This is an Emergency Safety Order to correct and remove an imminent danger.

This email serves as an **EMERGENCY SAFETY ORDER** in accordance with Nevada Administrative Code (NAC) 455C - Section 7, items 1-4.

Subject: E-Series 5000 Escalator -
Welds on Lower Track Sub-Assembly

Figure 1. Identification of weld areas

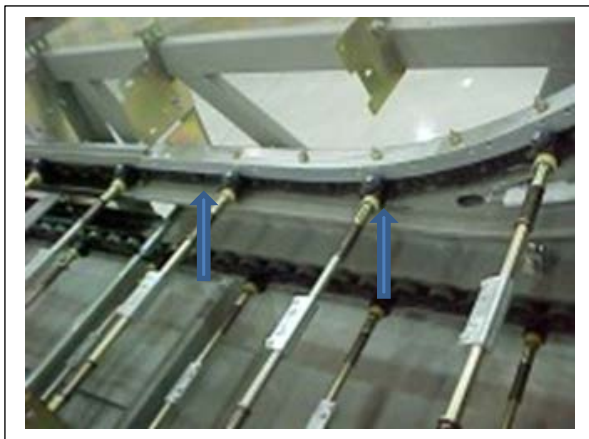
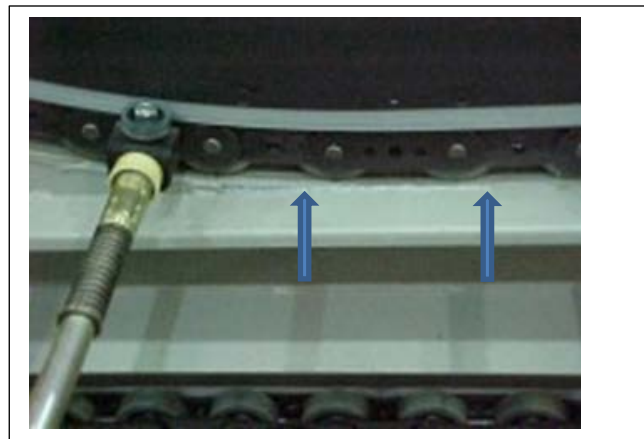
There have been instances of broken welds on the lower track sub-assemblies in the areas shown between the arrows of Figure 1 & 2.

The welds in the areas shown will be either on the top or on the bottom surface of the track and should meet the following criteria as a **minimum**:

- Welds should be 1/8 inch in width. Wider is acceptable as long as the step chain wheels do not roll against the weld.
- Welds should be 1/2 inch to 3/4 inch in length. Welds must **NOT** be shorter than 1/2 inch in length.
- Spacing from the center of one weld to the center of the next weld is to be no more than 8 inches. Closer spacing is good (although a continuous weld bead could cause distortion of the track sub-assembly).

If the existing welds do not meet the criteria specified above, a repair will be required to strengthen the welds.

If inspection reveals that the track is bent down in this area, an immediate repair is required.
Refer to the Repair Instructions below.

Figure 3 Additional Gusset to be added

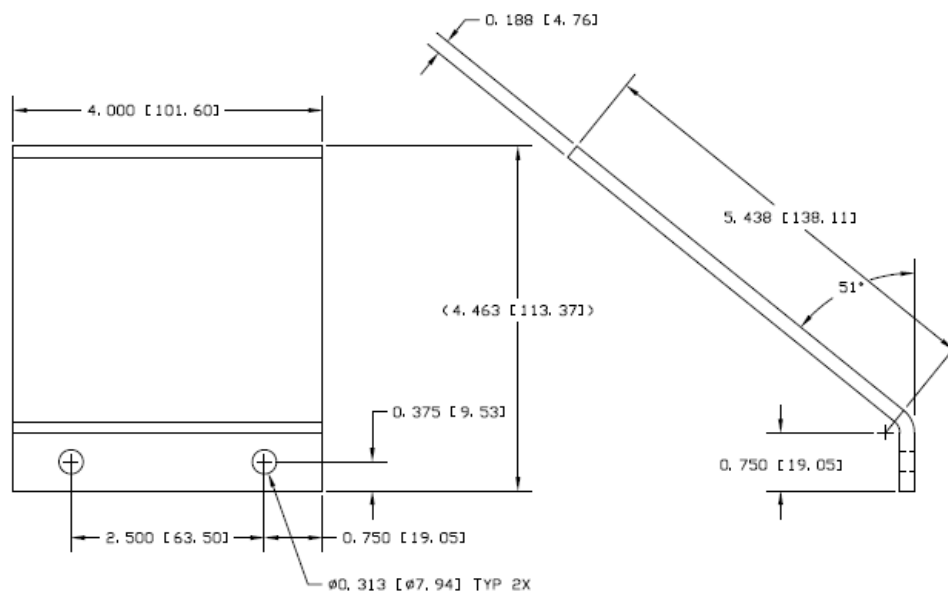
Add the stiffening gusset shown in Figure 3 in the location shown in Figure 4. The gusset will provide additional support to the track assembly and reduce the stresses experienced by the repair welds.

Figure 4 *Mounting of support gusset in lower track sub-assembly*

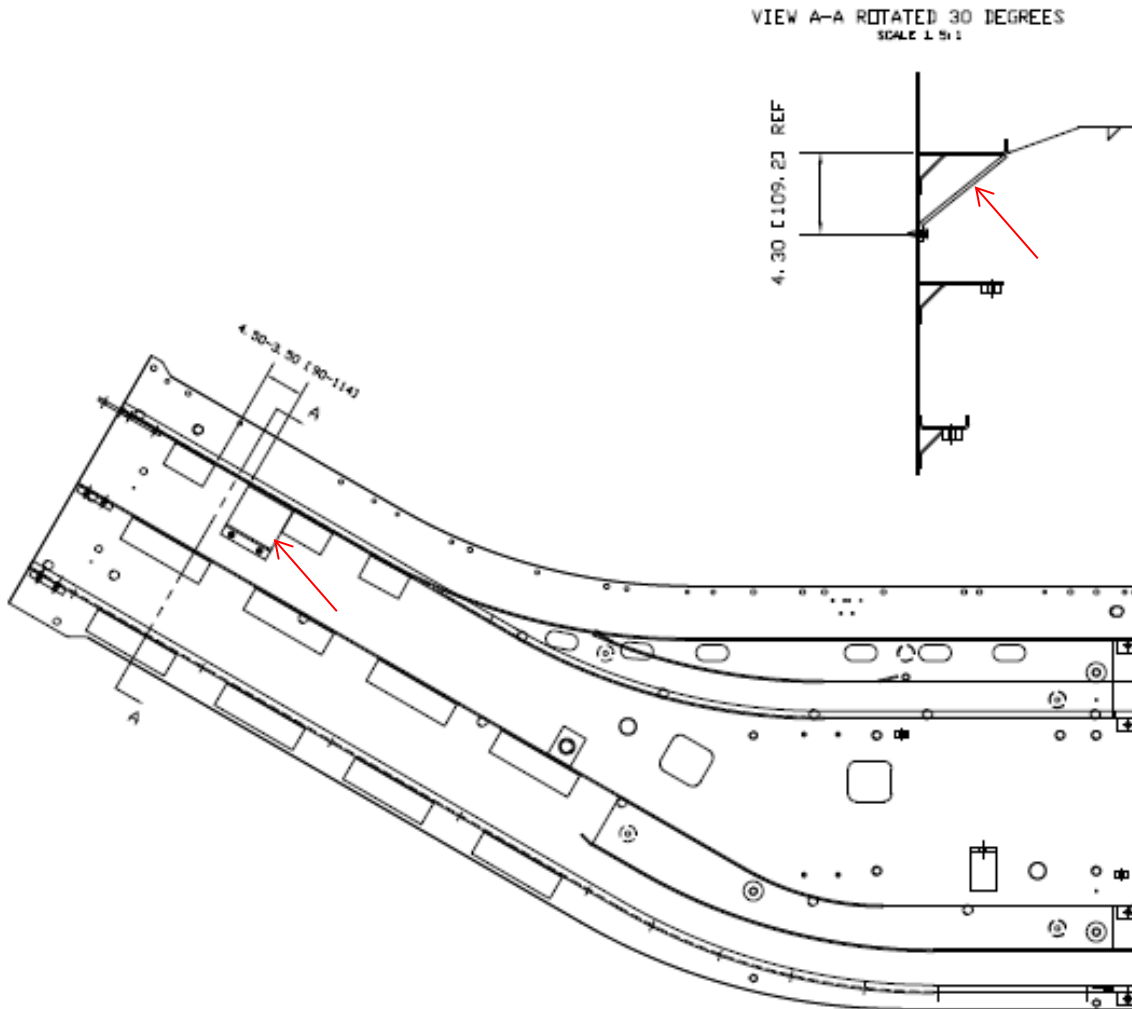
Align gusset in approximate location as defined in figure 4 above. Holding formed edge flat against track subassembly side sheet, position opposite edge on edge of track. Mark positions of holes provided in gusset.

Remove gusset.

Using a letter "F" drill bit [Decimal = 17/64 inch], drill holes through track sub side sheet in the locations previously defined.

Attach the gusset as shown using two (2) 5/16-18 (inch) self-tapping screws.

Weld the opposite (top) edge of the support gusset to the track profile. Add three welds 1/8 in. [3.3 mm] wide and 3/8 in.[9.7mm] long, with a center-to-center spacing of approximately 1.00 in. [25.4mm].

Avoid overheating the track profile as this can result in distortion of the profile.
